**IEEE P802.3dj  
200 Gb/s, 400 Gb/s, 800 Gb/s,  
and 1.6 Tb/s Ethernet Task Force  
Joint Logic / Electrical / Optical Ad  
hoc Meeting  
28 August 2025**

**Update – Optical MDI's Normative  
Connector Position(s)**

Figure 180A–2—Optical lane assignments for a single-row 12-position connector

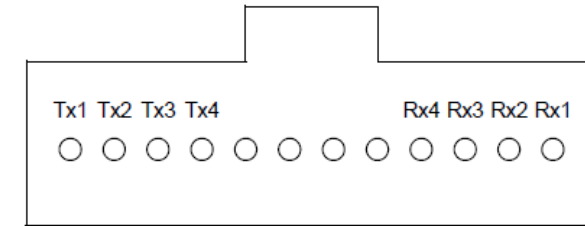
- **D2.0 Comment #523 was rejected due to “No consensus to make a change.”**
- **Current language in D2.1 (180A.4.1 and 180A.4.2) shown to right.**
- **In general, the text addresses a fully populated connector, then addresses a non fully utilized MDI connector.**

- **Based on real world fiber plant implications - two key applications the text needs to address:**
  - **Single PMDs (optical connector position(s) needs to be normative)**
  - **Combinations of PMDs**

Replace paragraphs after Fig 180A-2 and Table 180A-2 with the following:

Table 180A-2 shows the mapping of PMD signals to optical connector positions for single-row 12-position optical interfaces.

Such interfaces support a single one, two, or four lane optical PMD, such as 200GBASE-DR1, 200GBASE-DR1-2, 400GBASE-DR2, 400GBASE-DR2-2, 800GBASE-DR4, or 800GBASE-DR4-2. Alternatively, combinations of one lane optical PMDs, such as 200GBASE-DR1 or 200GBASE-DR1-2, or two lane optical PMDs, such as 400GBASE-DR2 or 400GBASE-DR2-2, are permissible.

For implementations where the eight connector positions are not fully utilized, the lower connector positions in Table 180A-2 shall be used. Table 180A-3 shows an example of a combination of the mapping of several optical PMDs to a fully utilized, single row, 12-position optical connector.

Figure 180A–3—Optical lane assignments for a single-row 16-position connector

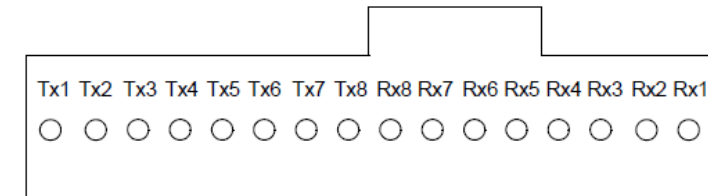
Replace paragraphs after Fig 180A-3 and Table 180A-4 with the following:

Table 180A-4 shows the mapping of PMD signals to positions for a single-row, 16-position optical connector.

Such interfaces support a single one, two, four, or eight lane optical PMD, such as 200GBASE-DR1, 200GBASE-DR1-2, 400GBASE-DR2, 400GBASE-DR2-2, 800GBASE-DR4, 800GBASE-DR4-2, 1.6TBASE-DR8, or 1.6TBASE-DR8-2. Alternatively, combinations of one lane optical PMDs, such as 200GBASE-DR1 or 200GBASE-DR1-2, two lane optical PMDs, such as 400GBASE-DR2 or 400GBASE-DR2-2, or four lane optical PMDs 800GBASE-DR4 or 800GBASE-DR4-2, are permissible.

For implementations where the 16 connector positions are not fully utilized, the lower connector positions in Table 180A-4 shall be used. Table 180A-5 shows an example of a combination of the mapping of several optical PMDs to a fully utilized, single row, 16-position optical connector.
